PERMIT AND VICINITY MAP
OAK GROVE RESOURCES, LLC
CONCORD PREPARATION PLANT
REVISION R-20 / P-3233
SECTIONS 21, 22, 23, 24, 26, 27, 28, 29, 30 & 34
TOWNSHIP 18 SOUTH, RANGE 5 WEST
SECTION 25, TOWNSHIP 18 SOUTH, RANGE 6 WEST
JEFFERSON COUNTY, ALABAMA
SHEET 2 OF 2

PERC
ENGINEERING CO., INC.
1606 Hwy. 78 West Jasper, AL 35501/P.O. Box 1712-35502
(205) 384-5653 Office (205) 295-3114 Fax

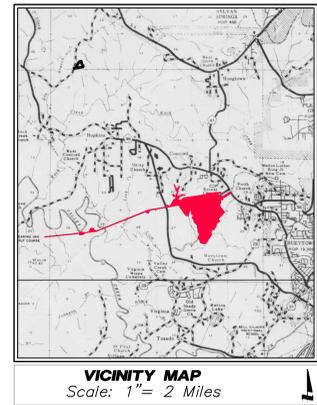
- NATURE OF REVISION R-1**
- 1.) Revise General Drainage Plan To Add Ponds 012 and 013, Access Roads and Drainage, 3 Acres Total.
 - 2.) Revise Permit Map To Correct Apparent Previous Error in Mapping The Location Of Overland Conveyor.

- NATURE OF REVISION R-2**
- 1.) Modify Slurry Ponds "A" and "B".
- NATURE OF REVISION R-3**
- 1.) Change Operation Plan To Include Underground Injection Of Washer Effluent Into The Abandoned Concord Underflow Mine.

- 2.) Add 13.0 New Acres To Permit Area (located in Section 22, Township 18 South, Range 5 West, Jefferson Co., AL.) to Increment No. 1 For Injection and Withdrawal Wells, and Access Road.

- NATURE OF REVISION R-4**
- 1.) Add Ponds 014, 015, 016, 017, 018, Access and Drainage (no acreage change).
 - 2.) Modify Existing Coal Processing Waste Dam and Embankment.

- NATURE OF REVISION R-5**
- 1.) Area Added To Permit For Coal Stockpiles, Storage Areas, and Access Road 36 Acres.

- NATURE OF REVISION R-6**
- 1.) Undisturbed Area Deleted from Permit, 18 Acres.
 - 2.) Area Added To Permit, 18 ACRES
 - 3.) Request for Exemption of Rule 880-X-100-.13(3) with Regard to Borrow Area and Scale Area.

- 4.) Update Drainage Control Plan with Regard to Basins 016, 017, and 018.
- NATURE OF REVISION R-7**
- 1.) Modify Detailed Design of Basin 18.
- NATURE OF REVISION R-8**

- Transfer 78 Acres from Increment No. 1 to create new Increment No. 2, Area Designated as Permit Area not to be Redisturbed.
 - Area added on Site for Non-Coal waste disposal area. (No Acreage change.)

- Area added to Permit for construction of Waterline, Drainage Courses, and Pump Intake Site, 1 Acre.
 - Update Drainage Control plan through the deletion of Basins 015 and 016, Re-creation of Basin 014, and the request of Exemption of rule 880-X-100-.13(3) with regard to the area designated as Permit Area not to be Redisturbed.

- NATURE OF REVISION R-9**
- Area Added to Increment No. 1 for Conveyor Support Area and Access, 10.0 Acres.
 - Area transferred from Increment No. 2 to Increment No. 1 for Borrow Cover Material, 4 Acres.
 - The request of Exemption of rule 880-X-100-.13(3) with regard to the area added as Conveyor Support Area located in the NE 1/4 of SE 1/4 of Section 30.
- NATURE OF REVISION R-10**
- Area Added to Increment No. 1 for Injection Well Sites, Pipeline Corridor, and Access, 2.0 Acres.
- NATURE OF REVISION R-11**
- Area Added to Increment No. 1 for Borrow Area, 23 Acres.

- NATURE OF REVISION R-12**
- Area Added to Increment No. 1 for Injection/Withdrawal Well Sites, Pipeline Corridor, and Access 13.0 Acres.
- NATURE OF REVISION R-15**

- Area Added to Increment No. 1, 2.0 Acres, 1.0 Acre For Overland Conveyor and Belt Drive House Support Area, 1.0 Acre for Ancillary Roads and 1.0 Acre for borrow area for the maintenance of the embankment of Concord Water Impoundment.

- Request to Expand Coarse Refuse Disposal Area, No Acreage Change. The Expansion will include Basin 019 (New Diked Slurry Impoundment)
 - Request to abandon Basin 019 (New Dike Slurry Impoundment) by its Billing through the expansion of Coarse Refuse Disposal Area.

- Request for exemption of Rule 880-X-100-.13(3) for an area within the NE 1/4 of the NE 1/4 of Section 27 and the NE 1/4 of the NW 1/4 and the NW 1/4 of the NE 1/4 of Section 28, all within Township 18 South, Range 5 West, Jefferson County, Alabama.

- NATURE OF REVISION R-16**
- Request to add 2.0 Acres for Ancillary Road(s) to Increment No. 1.
- NATURE OF REVISION R-17**
- Request to add 2 acres to Increment No. 1 for a Pipeline Crossing.
 - The request of Exemption of Rule 880-X-100-.13(3) for the Pipeline Crossing added by this Revision.
- NATURE OF REVISION R-18**
- Request to update the Operations Plan to include a Modification to the Coarse Refuse Disposal Plan.
 - Submit the Detailed Design Plans for the Modification of the Coarse Refuse Disposal Plan.
 - The eastern expansion of the Coarse Refuse Disposal Plan included in the Detailed Design Plans will be addressed in a subsequent revision.
 - No Acreage Change.
- NATURE OF REVISION R-19**
- Area Added to Increment No. 1, 31.0 Acres, For Injection & Withdrawal Wells and Access Roads.

- NATURE OF REVISION R-20**
- Request to update Operations Plan to include a Modification to the Coarse Refuse Disposal Plan and Slurry Impoundment No. 3 which is contained within the Coarse Refuse Area.
 - Submit the Detailed Design Plans for the modification of the Coarse Refuse Disposal Area and Slurry Impoundment No. 3.
 - No acreage change.
